China's Explanation of HV Safety

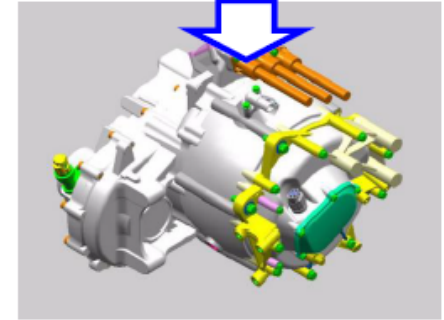
Add an alternative approach.

Alternatively, the calculation of total energy TE_y may be conducted according to the formula below with using V_b.

$$TE_y = TE_{y1} + TE_{y2} \equiv 0.5 \times C_y \times V_b^2$$

C_y: C_{y1} or C_{y2} whichever is higher

Should be " < "

- Comment : in China' s new GB ,C_y is defined as the sum of all capacitor in positive side or negative side which is higher .

- Review : the flowing formula , equivalent calculation of new GB, can be an alternative approach.

$$TE_y = 0.5 * C_y * V_b^2$$
